Reference: 24168-RGB-ZZ-XX-CO-ST-0003-SJ: DA 251031

RE: STRUCTURAL DESIGN CHANGE – CAR PARK WALLS PUSHED OUT FROM PREVIOUS SSDA LAYOUT

Figure 2: Revised SSDA design – Short section

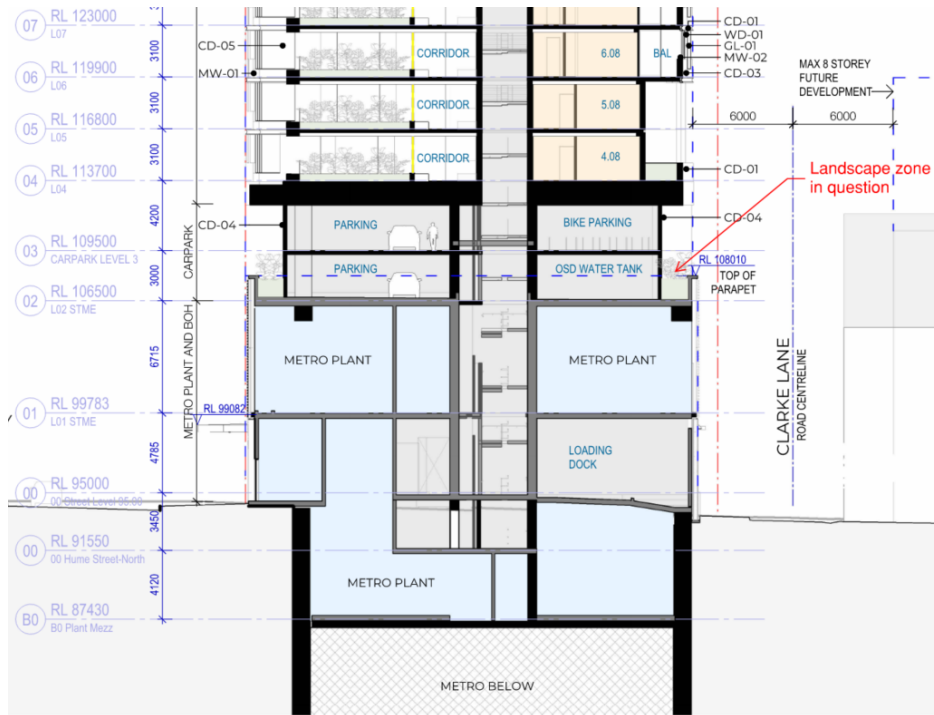
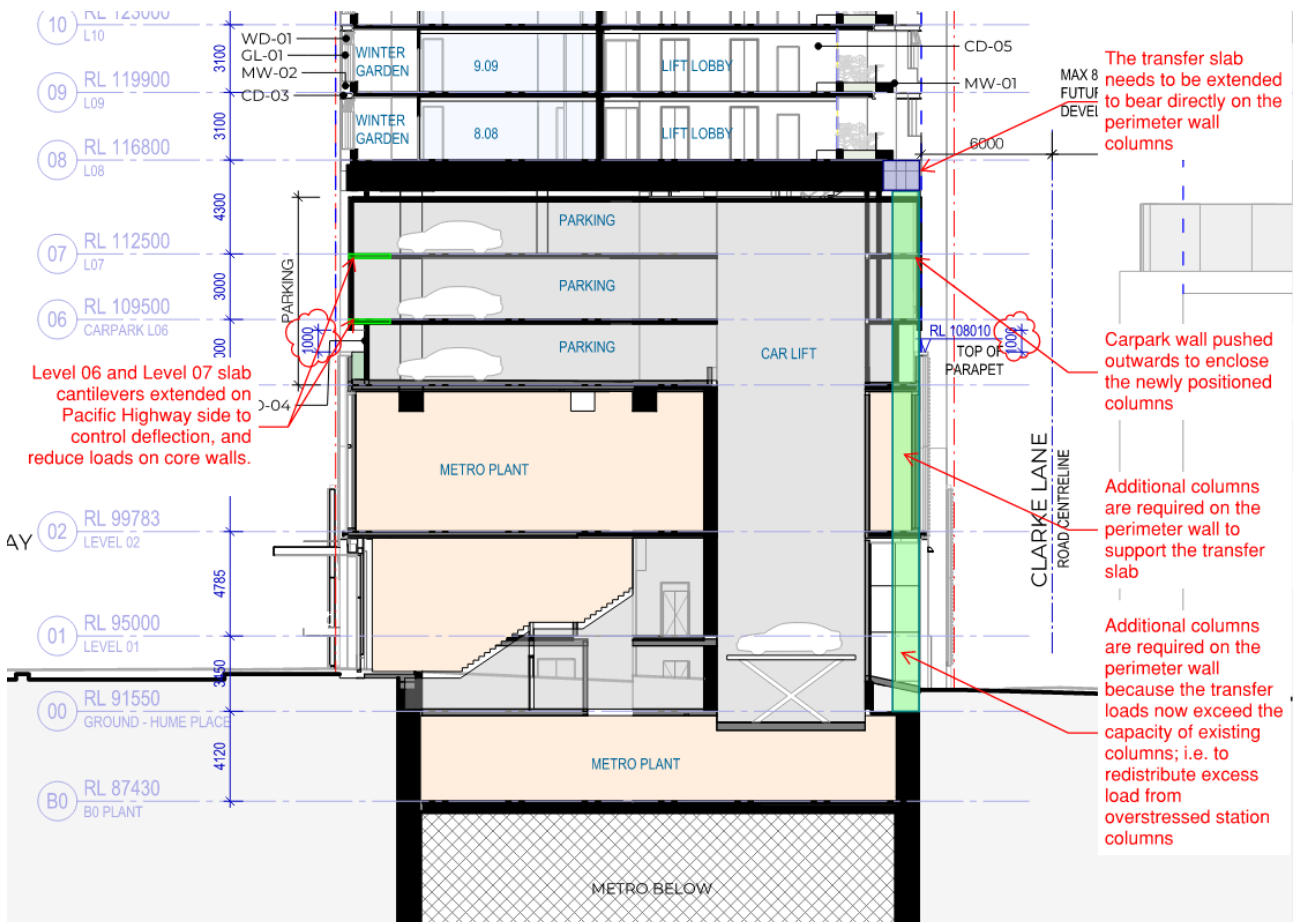
- As the structural design has developed from concept phase into a more detailed design, we have identified crucial structural requirements, necessitating alteration of the originally approved SSDA layout (Fig. 1 → Fig. 2 and Fig. 3 → Fig. 4).
- In summary, the perimeter car park walls have been moved outward on Clark Lane to align with newly added perimeter columns. The perimeter car park walls have also been moved outward on Pacific Highway to control mid-span slab deflections and on Level 06 and 07. A transfer wall has been added between Level 05 and Level 07 on the Hume Street elevation to support Level 08 transfer slab.
- These modifications ensure the structural integrity of the over station development while protecting the metro infrastructure below. The structural rationale for the proposed changes is discussed at length in Section 2, 3, and 4.

- With the carpark wall relocation, new perimeter columns now directly support loads from the underside of the Level 08 transfer slab and beams.
- Without extending the columns on the perimeter wall vertically, there would be discontinuities in the load path, resulting in unsupported cantilevers and inefficient load transfer.
- Extending columns upward restores continuity, ensuring loads from Level 08 are effectively transmitted down through the structural system to the foundation.

Figure 5: Comparing Level 06 mid-span deflections of revised SSDA design and original SSDA design.

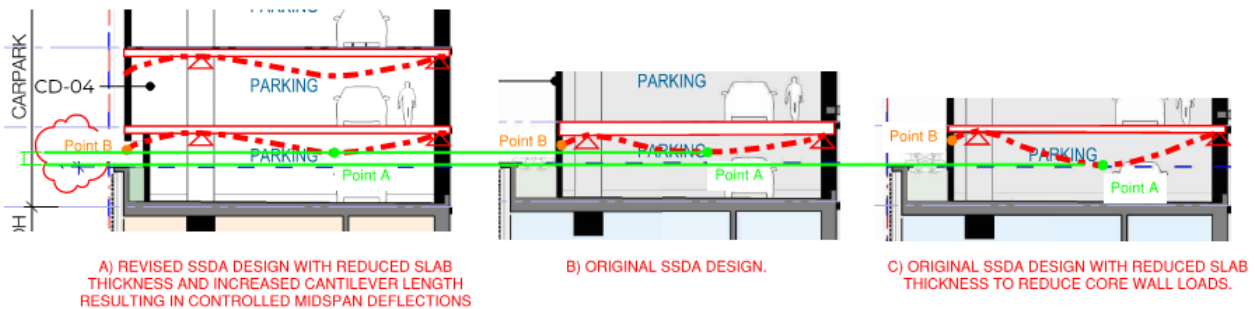
- There is a structural requirement to reduce the extent of loads carried by the core between the original SSDA design, and the revised SSDA design. To achieve this, the thickness of slabs on Level 6 and Level 7 in the revised SSDA need to be reduced. Reducing the thickness of such slabs increases deflection beyond project limits, therefore the length of the cantilever at Point B as shown in Figure 5 needs to be extended to control midspan deflections at Point A.
